METROPOLITAN GOVERNMENT OF NASHVILLE AND DAVIDSON COUNTY

STAFF RECOMMENDATION 1108 Gartland Avenue February 15, 2017

Application: New construction- detached accessory dwelling unit; Setback determination

District: Lockeland Springs – East End Neighborhood Conservation Zoning Overlay

Figure 2: 1951 Sanborn map

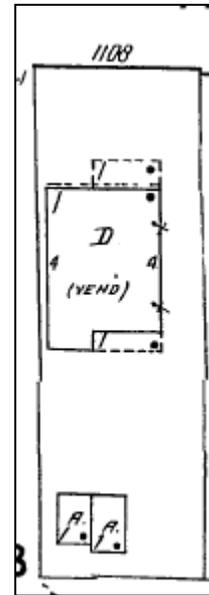
rear property line and five feet (5') from the side property lines. In this case, the seven hundred and forty-six square foot (746 sq. ft) structure is located twenty feet (20') from the left side property line, but it is located three feet (3') from the right side property line and eight feet (8') from the rear property line. Staff finds that the proposed rear setback is appropriate since historically outbuildings were located closer to the rear property line. In addition, the 1951 Sanborn map shows that a detached accessory structure was located near the rear property line at this site (see Figure 2). Therefore, staff finds that the proposed eight foot (8') rear setback is more historically appropriate than a twenty foot (20') rear setback and recommends approval of the setback determination. Staff also finds that the proposed right side setback of three feet (3') is appropriate as the accessory structure shown on the 1951 Sanborn map was located closer to the right side property line. In addition, the property is abutted by an alley on the right side as well as the rear, so the DADU shall be closer to the alley rather than a neighboring property. For these reasons, staff recommends approval of the rear and right side setback determinations.

SITE PLAN

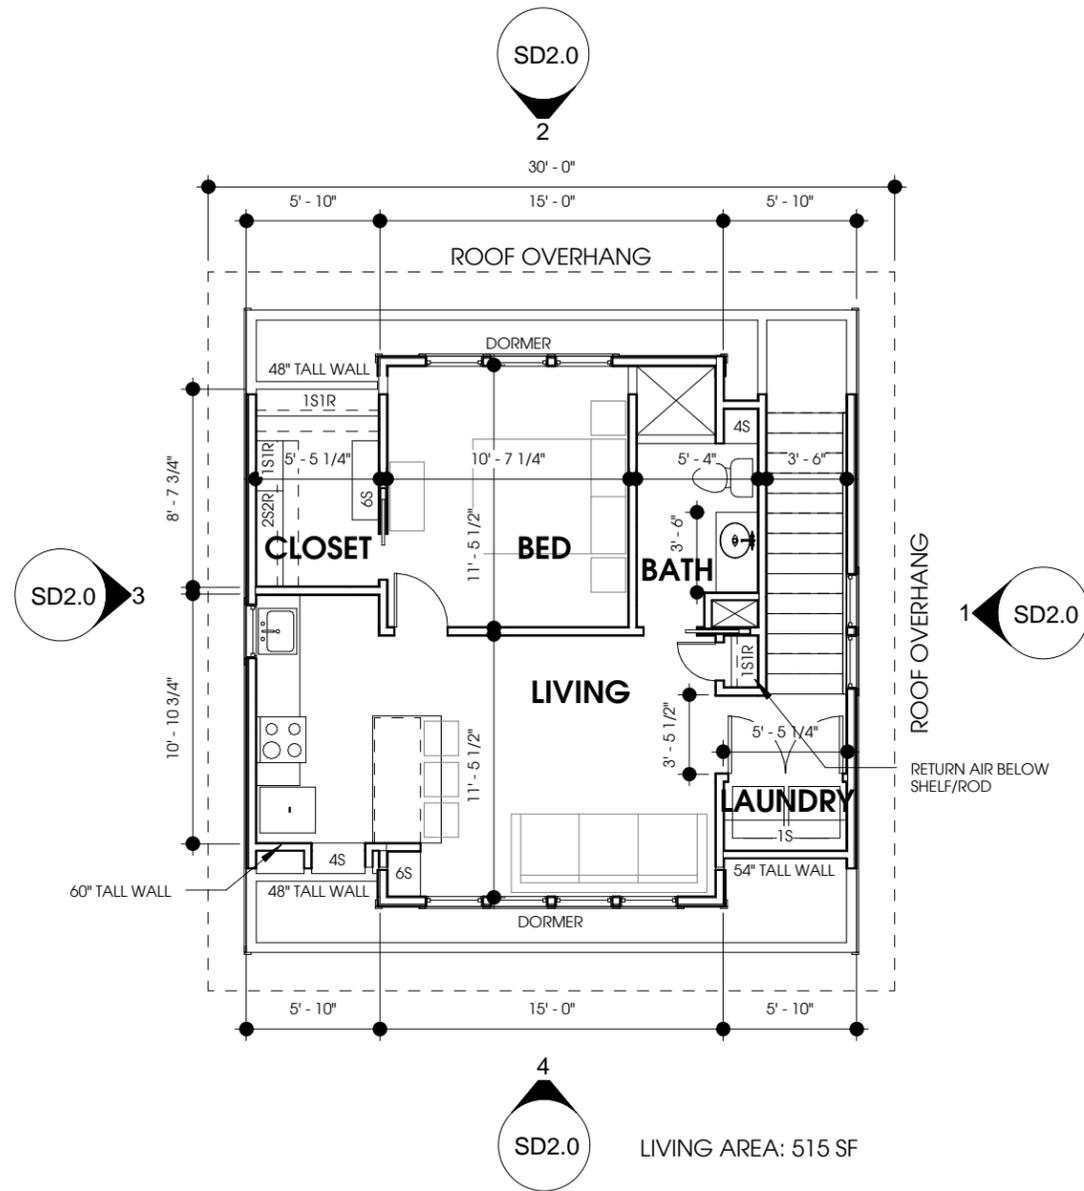
Setbacks: When an outbuilding has a footprint greater than seven hundred square feet (700 sq. ft.), bulk zoning requires that the structure be located twenty feet (20’) from the

Appurtenances & Utilities: The DADU will be accessed from the alley at the rear via a concrete driveway. The plan indicates that the HVAC will be located on the left side of the DADU, beyond the midpoint. Staff finds that this meets Section II.B.8 of the design guidelines.

MINIMUM	PROPOSED
Space between principal building and DADU/Garage	20'	38'
Rear setback	20'	8'
L side setback	5'	5'
R side setback	5'	3'
How is the building accessed?	From the alley or existing curb cut	Alley

With approval of the rear and right side setback determinations, staff finds that the project meets Section II.B.8. of the design guidelines and 17.16.030.G. 4 of the ordinance.

With approval of the rear and right side setback determinations, staff finds that the

ELEVATIONS

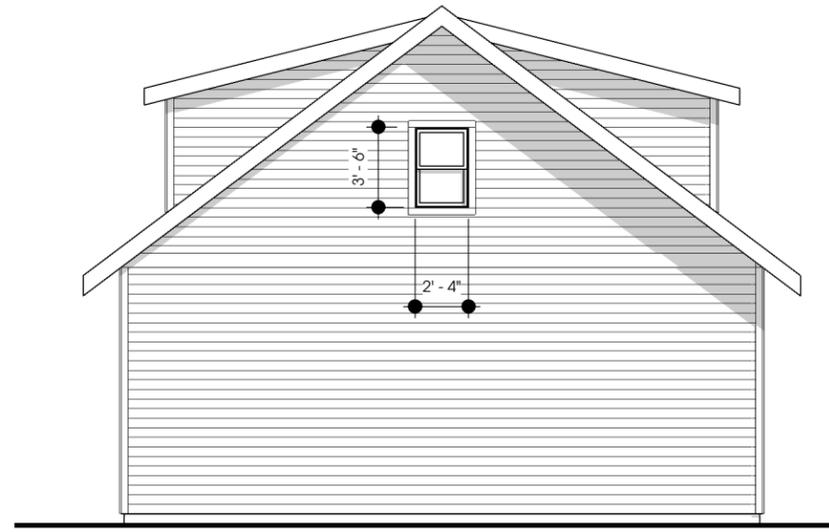
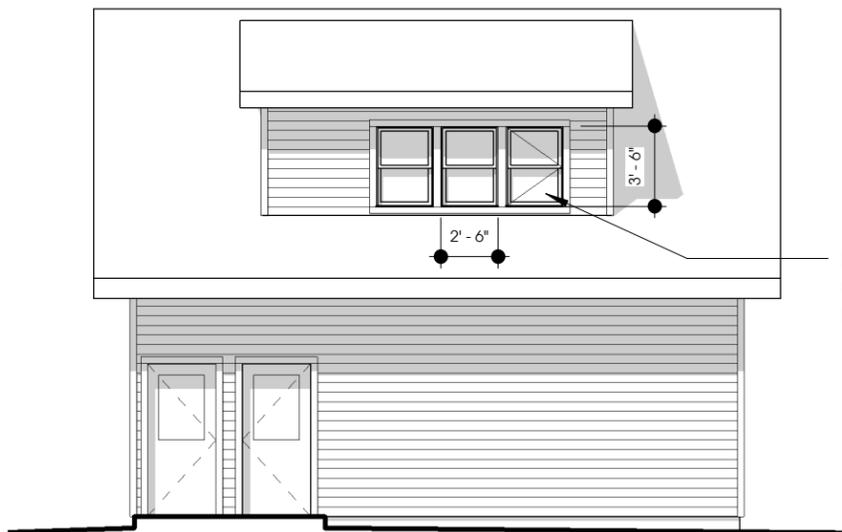
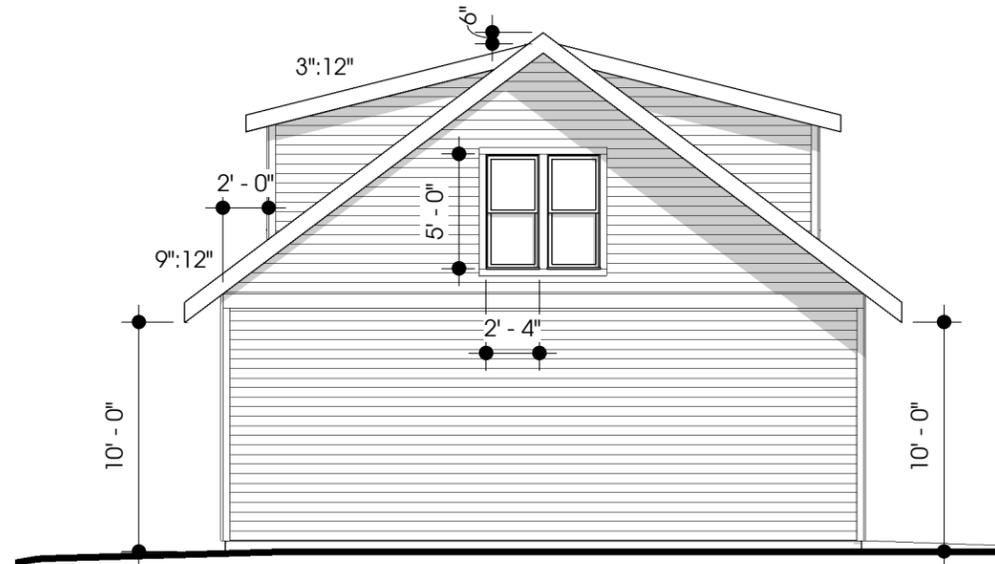
Roof Shape:

Proposed Element	Proposed Form	Typical of district?
Primary form	Side-gable	X
Primary roof slope	9/12	X
Dormer roof slope	3/12	X
Porch form	n/a	n/a
Porch slope	n/a	n/a

Since the form and slopes are similar to historic outbuildings, the project meets Section II.B.8 of the design guidelines and section 17.16.030.G.8 of the ordinance.

The accessory structure has a simple, utilitarian design that is appropriate for outbuildings. Its roof form, detailing, fenestration pattern, and form do not contrast greatly with the primary structure. It is also in a minimally-visible location at the rear of the historic house. Staff finds that the DADU’s design meets section II.B.8 of the design guidelines and Section 17.16.030.G.8 of the ordinance.

Proposed	Color/Texture	Approved Previously or Typical of Neighborhood
Foundation	Slab	natural	X
Cladding	Fiber cement siding	Smooth, 5” reveal	X
Roofing	Asphalt shingles	To match existing	X
Trim	Fiber cement boards	Smooth	X
Windows	Not indicated	Needs final approval	X
Pedestrian Doors	Half-light doors	Needs final approval	X
Vehicular Doors	Not indicated	Needs final approval	
Driveway	Concrete	Natural	X

Existing conditions (height of historic portion of the home to be measured from finished floor)	Potential maximums (heights to be measured from grade)	Proposed (should be the same or less than the lesser number to the left)
Ridge Height	27'	25'	22'-6"
Eave Height	11'	1 story 10'	10'

With the staff’s final approval of the windows, pedestrian and garage doors, and roof color, staff finds that the known materials meet Section II.B.8.
